Enclosure 2

TMI-1 Technical Specification Revised Pages for LCA No. 287

Certificate of Service for
TMI-1 License Change Application No. 287

FIGURE 3.3.1
Makeup Tank Pressure vs Level Limits
 (Instrument Error NOT Included)

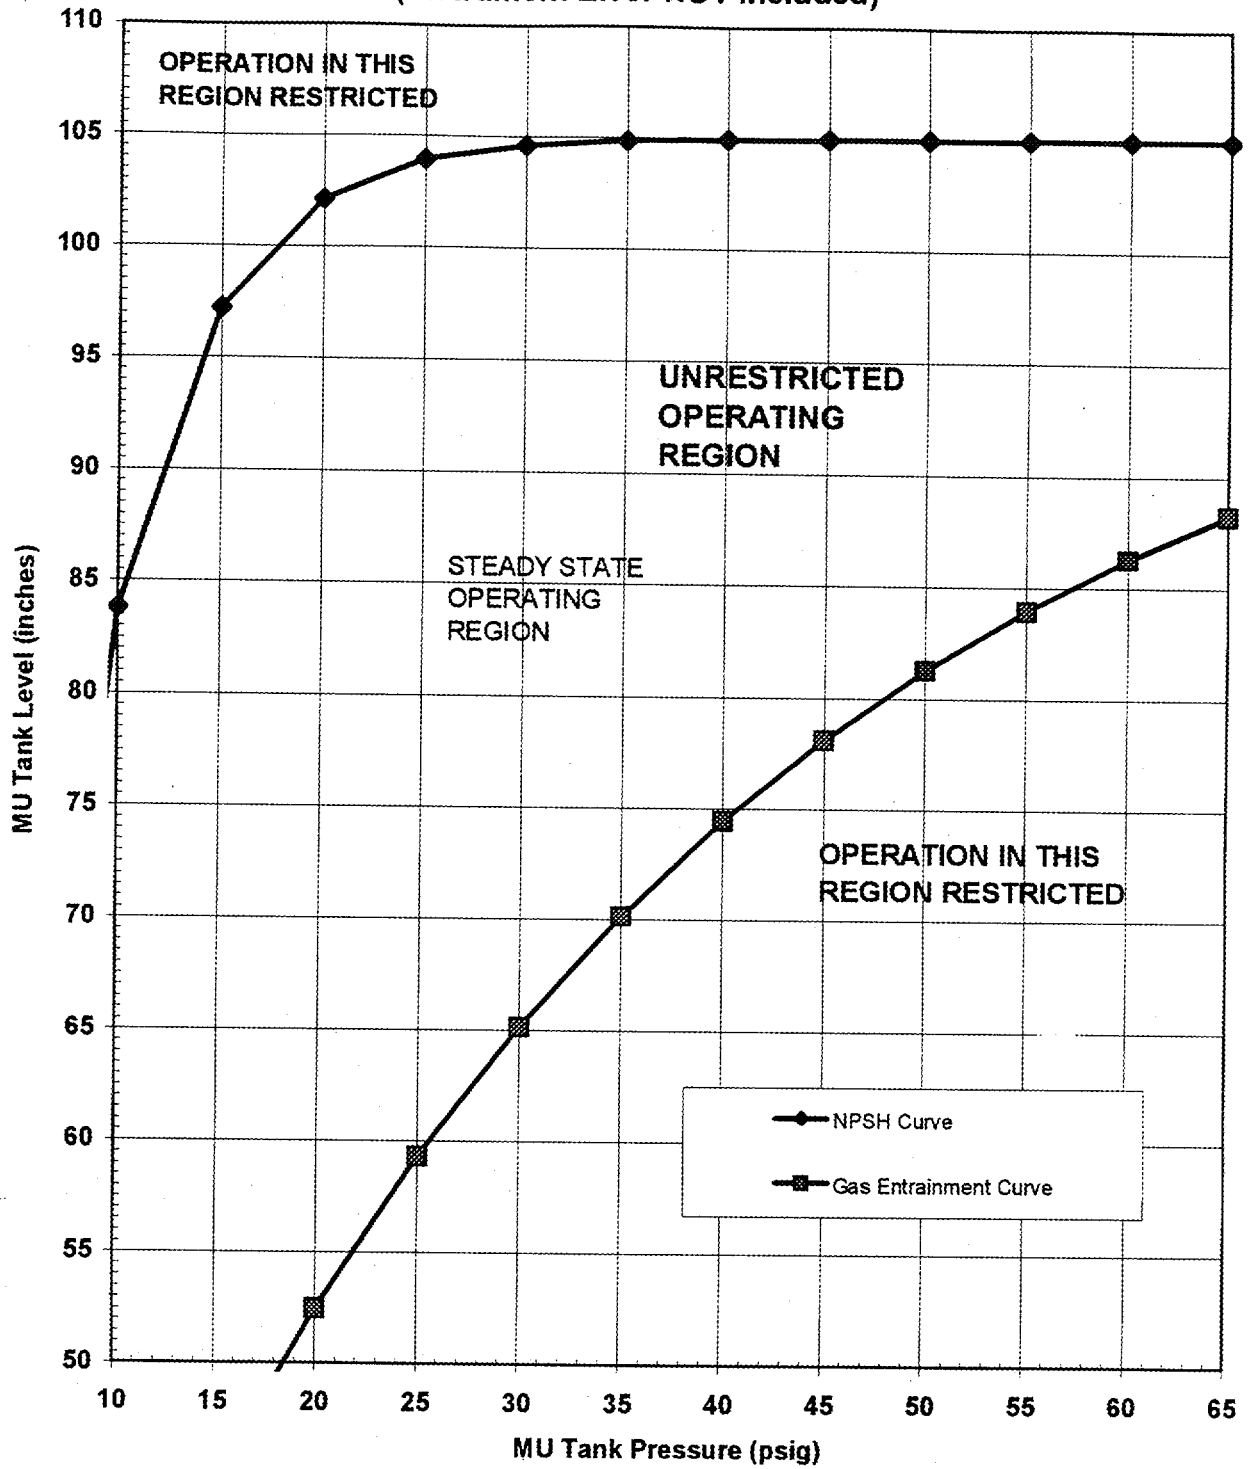
- g. **MU Tank (MUT) pressure and level shall be maintained within the Unrestricted Operating Region of Figure 3.3.1. With MUT conditions in the Restricted Region of Figure 3.3.1, restore MUT pressure and level to within the Unrestricted Operating Region within 4 hrs. Specification 3.0.1 applies.**

Maintaining MUT pressure and level within the limits of Fig 3.3.1 ensures that MUT gas will not be drawn into the pumps and the pumps will have adequate net positive suction head (NPSH) for any design basis accident. Preventing gas entrainment of the pumps is not dependent upon operator actions after the event occurs. The NPSH limit is necessary only to preclude damage to an HPI pump if it is started prior to an ES Actuation. The plant operating limits (alarms and procedures) will include margins to account for instrument error.

FIGURE 3.3.1
Makeup Tank Pressure vs Level Limits
(Instrument Error NOT Included)

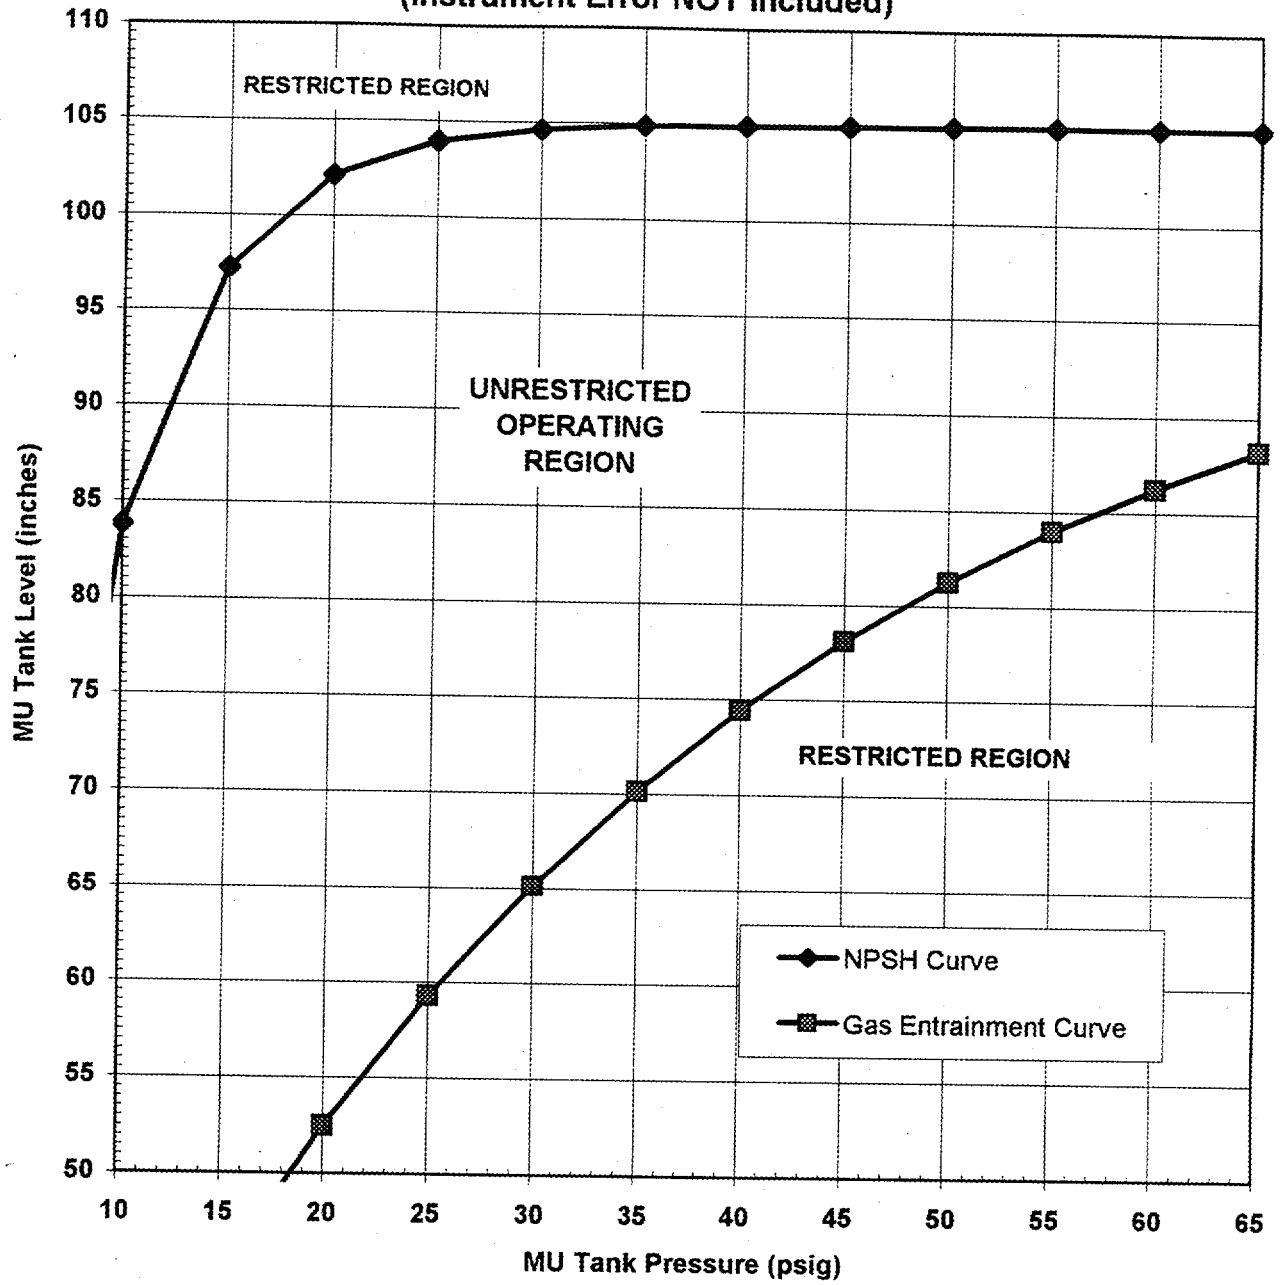
MU Tank (MUT) pressure and level shall be maintained within the Unrestricted Operating Region of Figure 3.3.1. With MUT conditions in the Restricted Region of Figure 3.3.1, restore MUT pressure and level to within the Unrestricted Operating Region within 4 hrs. Specification 3.0.1 applies.

Maintaining MUT pressure and level within the limits of Fig 3.3.1 ensures that MUT gas will not be drawn into the pumps and the pumps will have adequate net positive suction head (NPSH) for any design basis accident. Preventing gas entrainment of the pumps is not dependent upon operator actions after the event occurs. The NPSH limit is necessary only to preclude damage to an HPI pump if it is started prior to an ES Actuation. The plant operating limits (alarms and procedures) will include margins to account for instrument error.
